February 20, 2024

Koren Lam, MSc., Senior Planner  
County of Lanark  
99 Christie Lake Road,  
Perth, ON K7H 3C6

**Re: Brown Lands  
Draft Plan of Subdivision Resubmission  
Comment Response Letter  
File No. 09-T-23005**

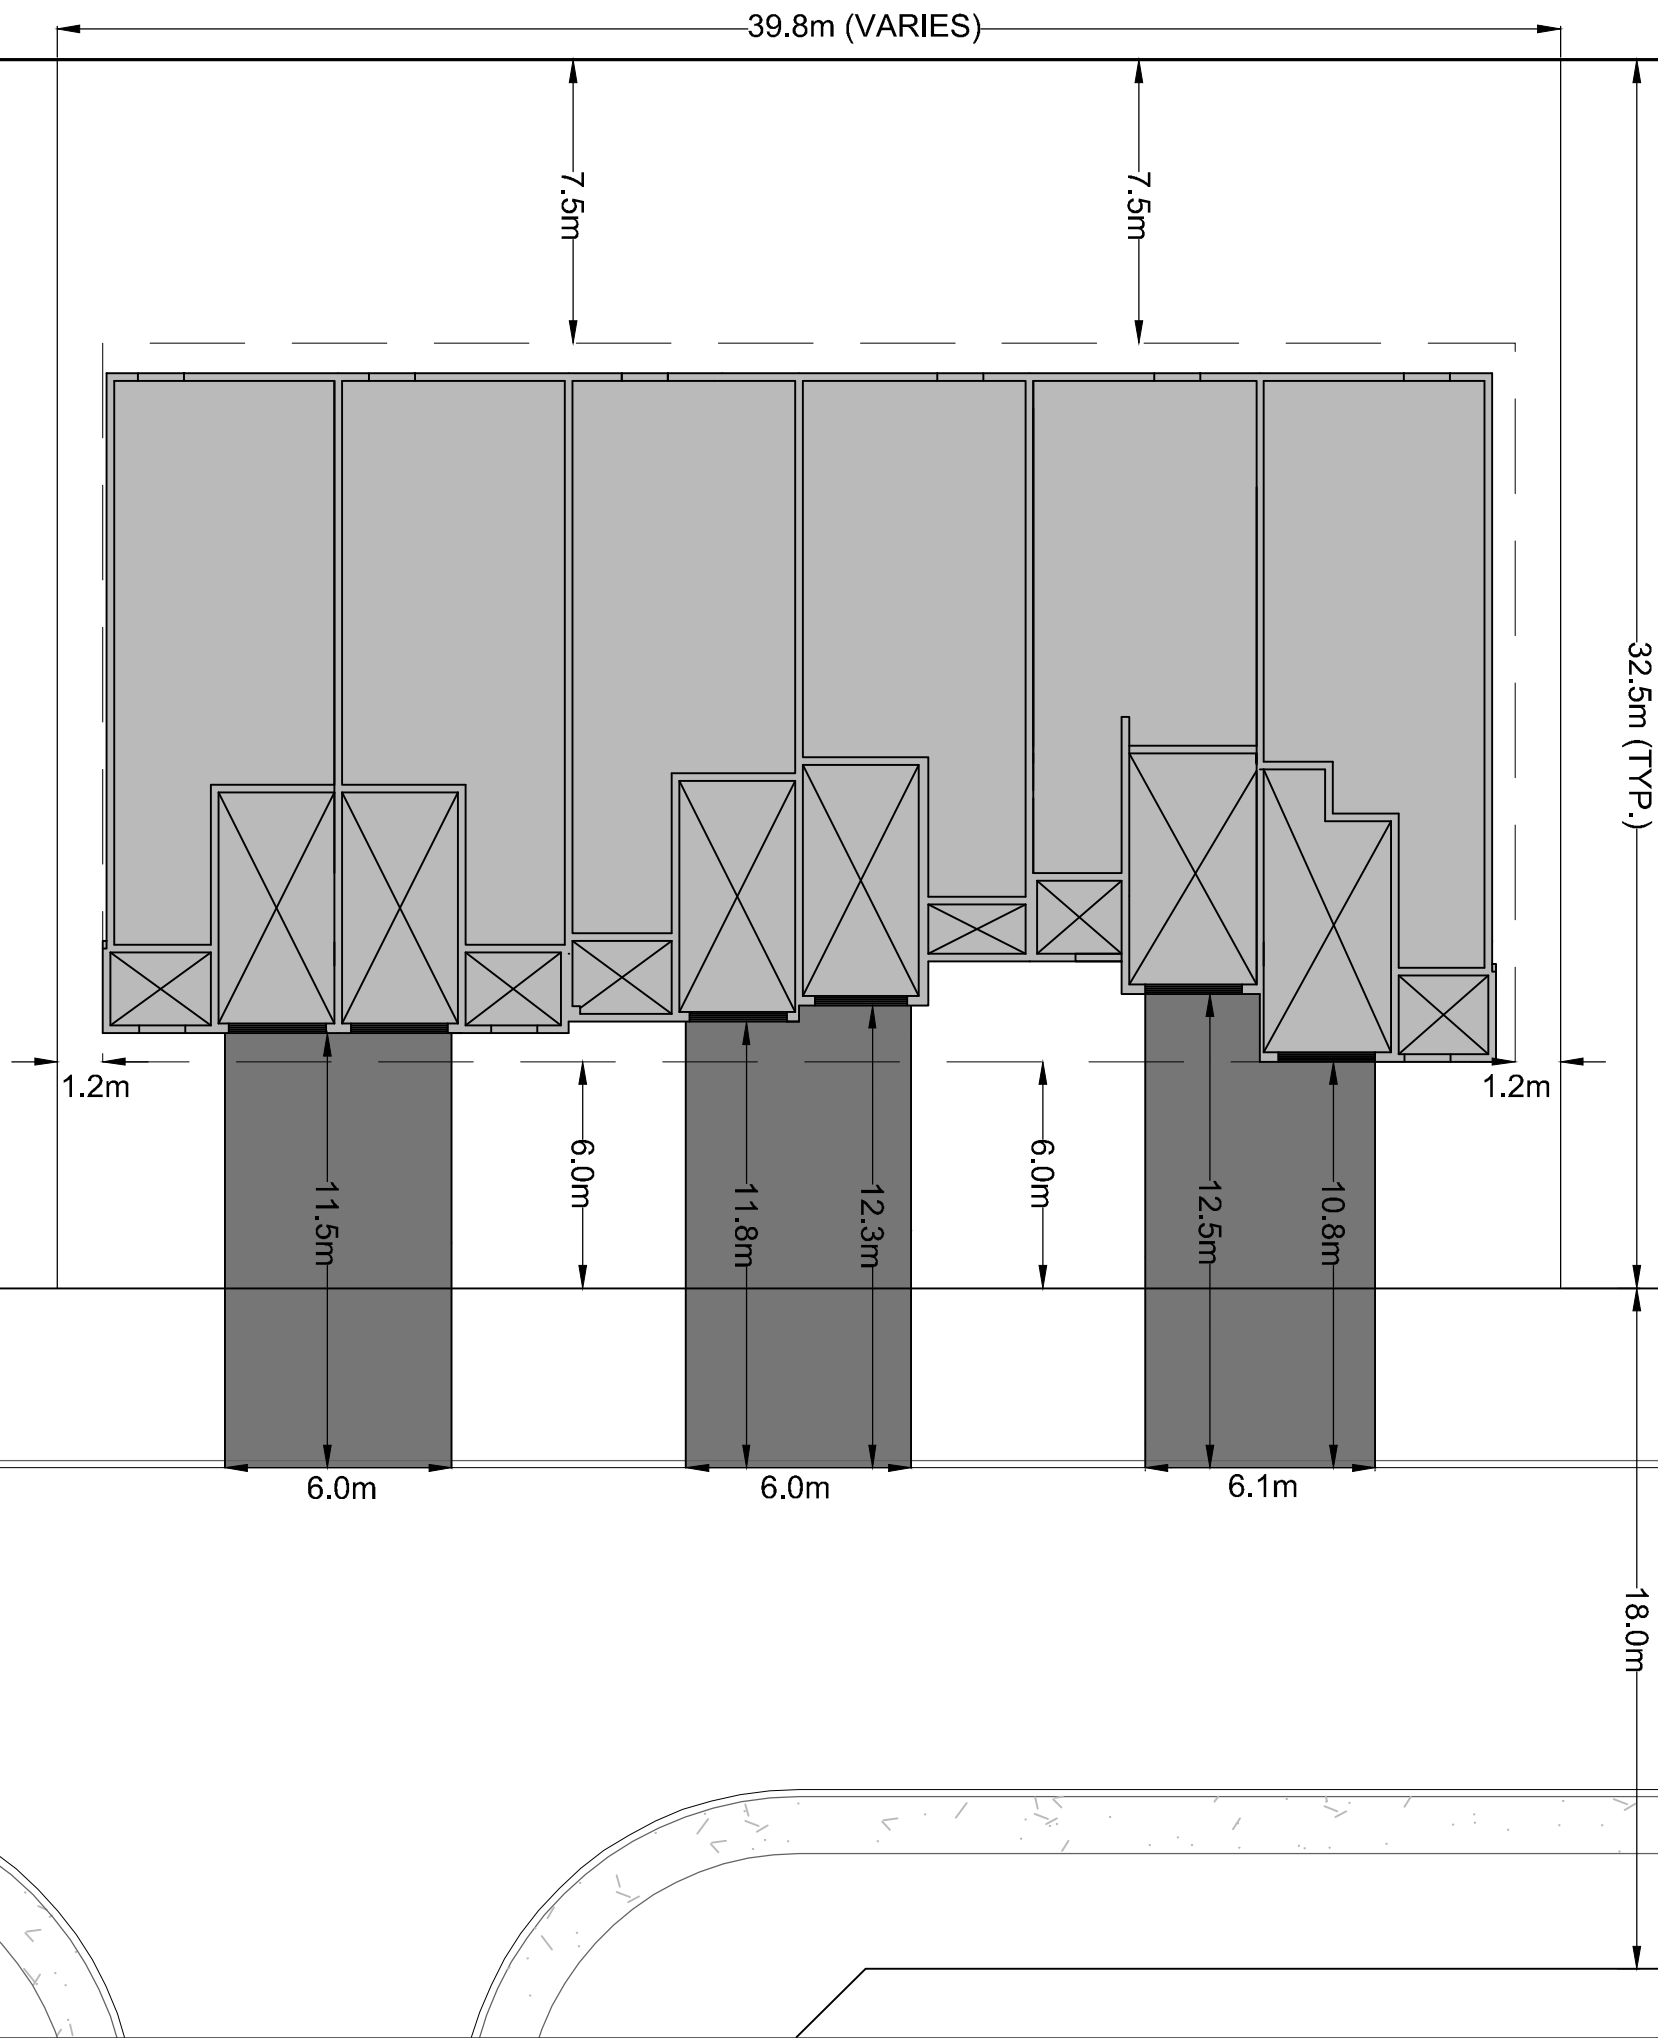
Step 7 - Based on the existing data (which needs to be confirmed per items above), many of the models are indicated appear to exceed the water supply needed, including singles; however, this needs to be confirmed by the applicant.

**Novatech: Step 7 of the OBC Water Supply for Firefighting Calculation spreadsheet is the required volume of water required for fire protection. This volume is used for buildings where a municipal water supply is not available. Where a municipal water supply is present, the system can provide large fire flow volumes so the limiting factor for consideration of during the design of the water network is the minimum supply flow rate that is required (Step 5).**

TYPICAL SITE PLAN - 6-UNIT (6-1)  
 TWO-STOREY TOWNHOME BLOCK

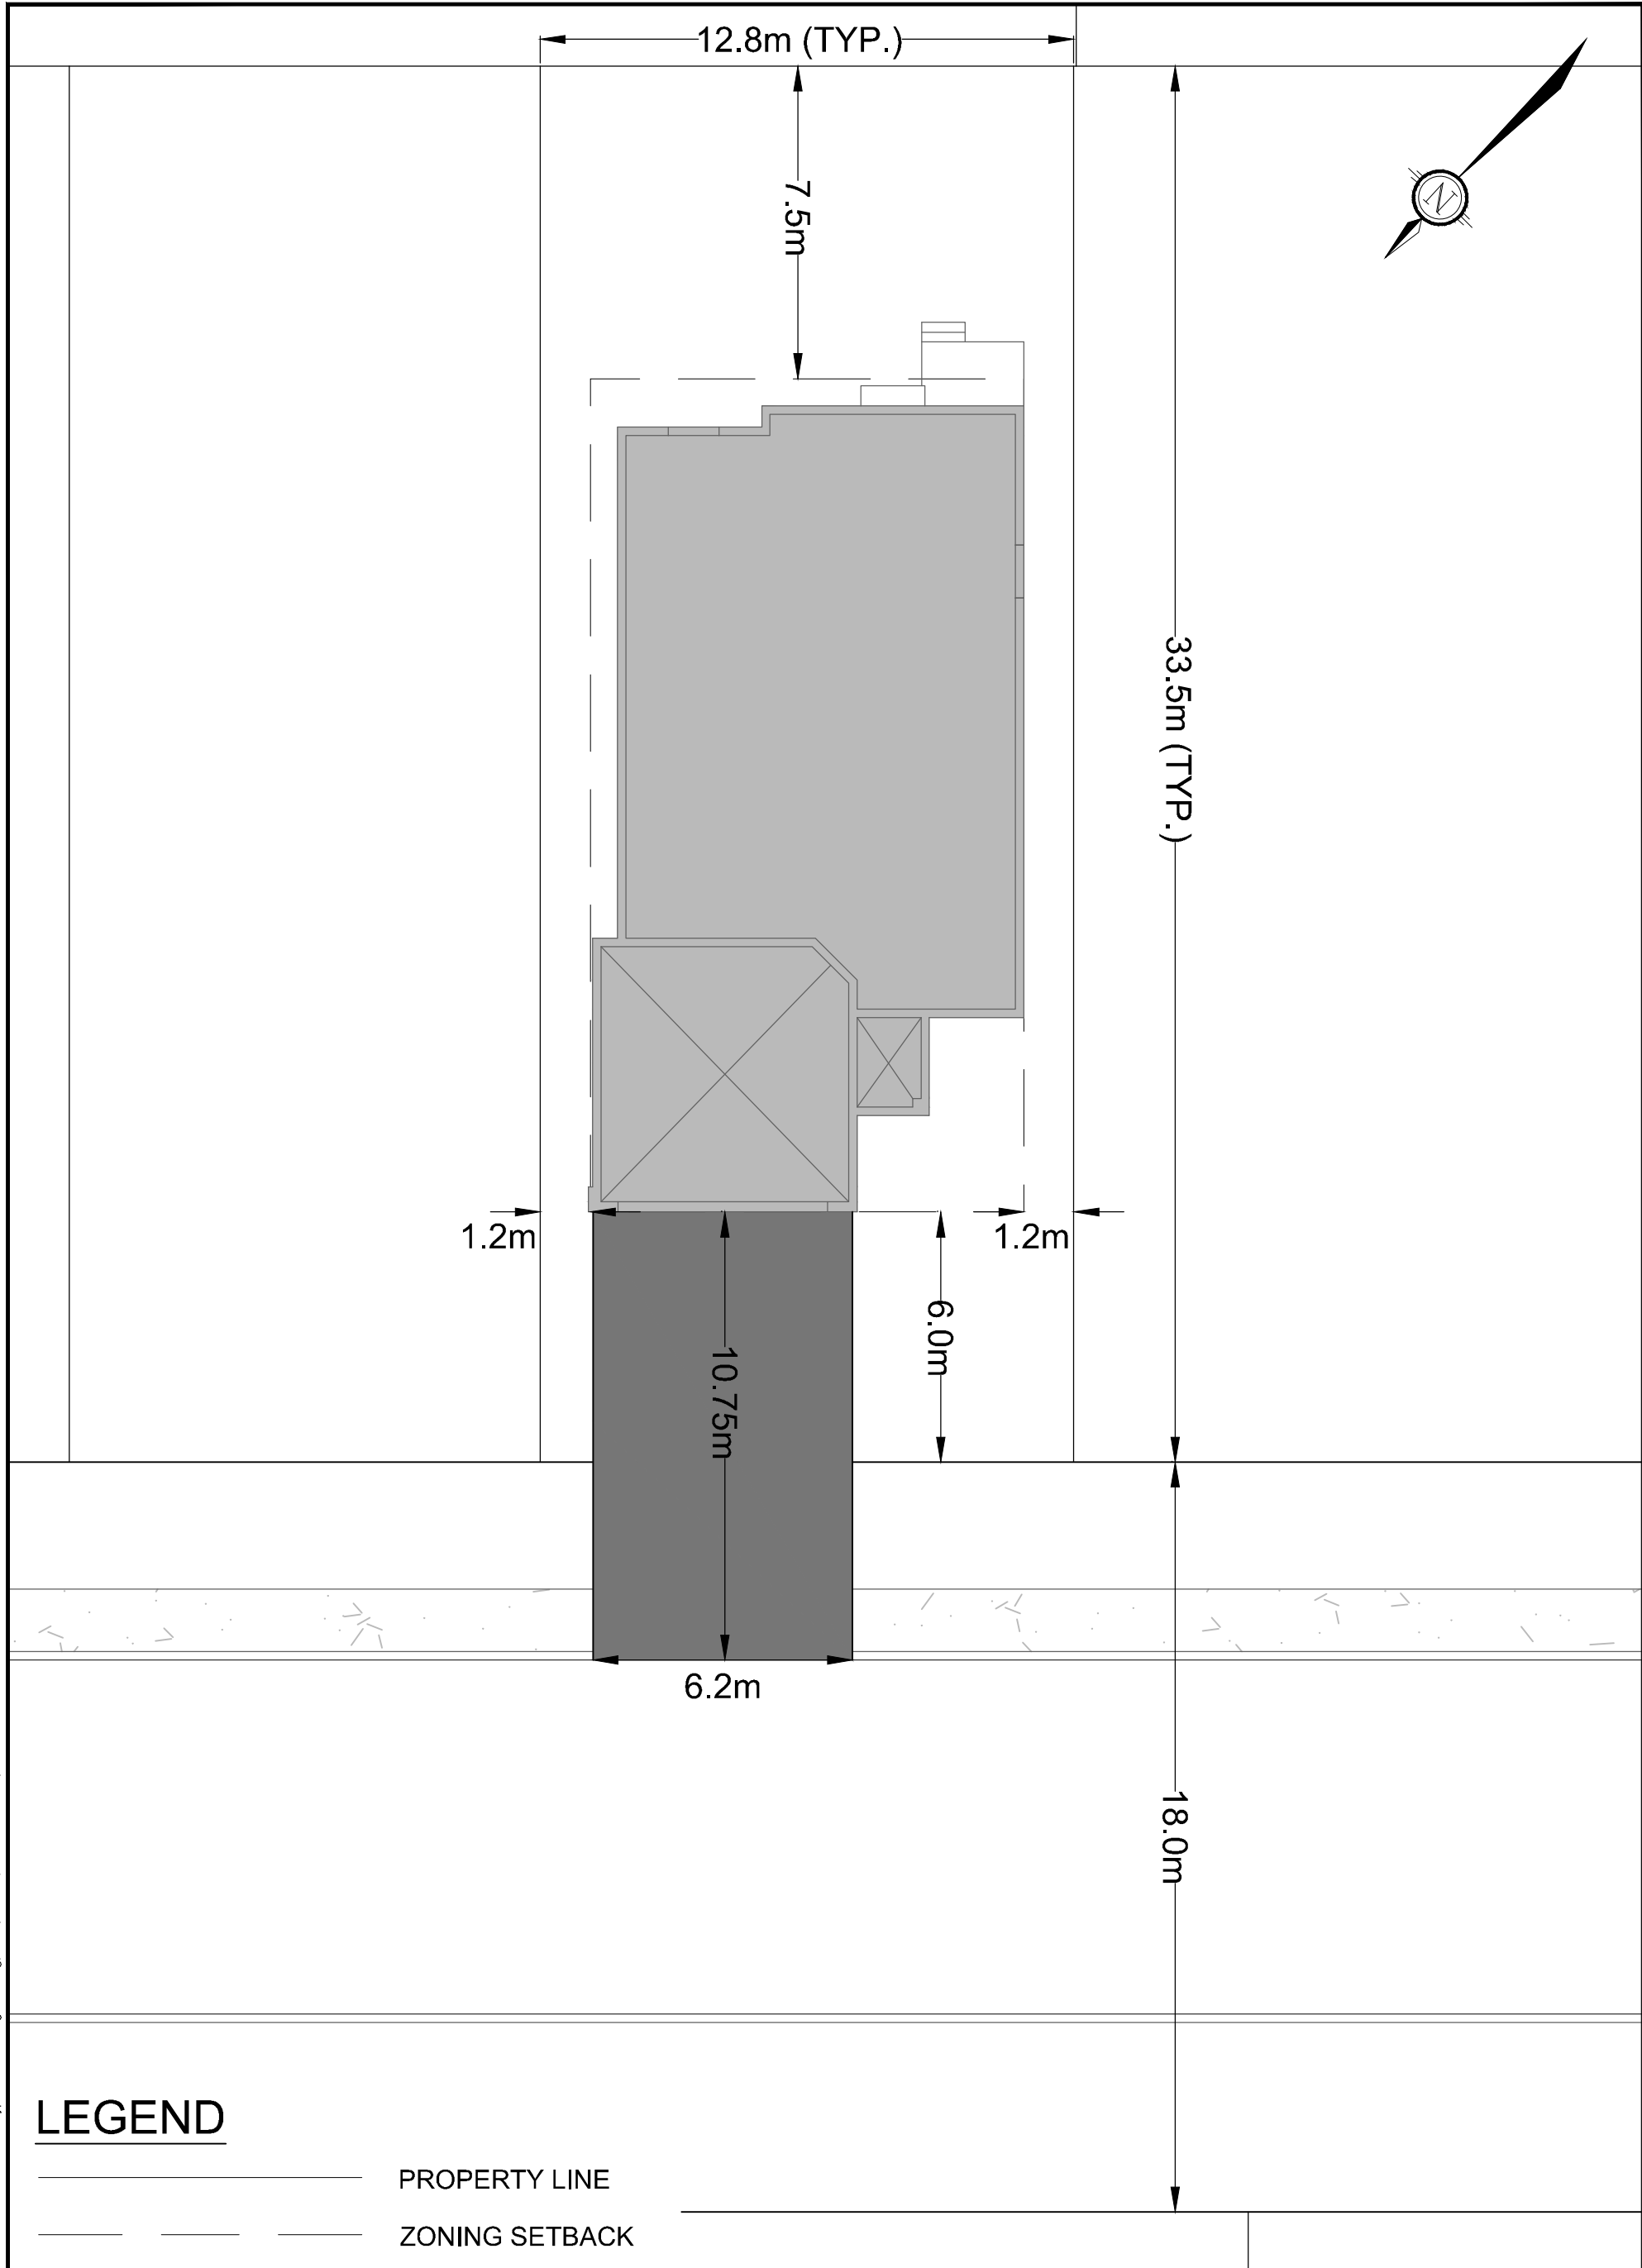
5. Please be advised that further comments will be provided after the resubmission regarding zoning. There are a number of zoning related items regarding parking that the Department will review including but not limited to, garage setbacks, sufficient on-site parking requirements in light of Bill 23 permissions with Additional Residential Units. Consideration of the design of the lots should incorporate the parking of vehicles on-site, preferably two vehicles per lots (can be in tandem). The Department would appreciate receiving conceptual site plans for each standard type of lots proposed with the proposed building envelopes to ensure that the proposed lots (and associated zoning) can accommodate an appropriate building envelope as well as on-site parking.

**Regional Group:** We will await further response from the Municipality regarding specific zoning comments. In the interim, we have provided conceptual sketches of a typical 42' lot and a typical six-unit townhouse block attached to this comment response letter. The sketches demonstrate that the builder's standard building envelope is compliant with the proposed Zoning provisions as well as the Municipality's parking space requirements, which currently requires one space per dwelling unit. The standard builder footprint can accommodate at minimum one vehicle in the garage and an additional vehicle in the driveway.
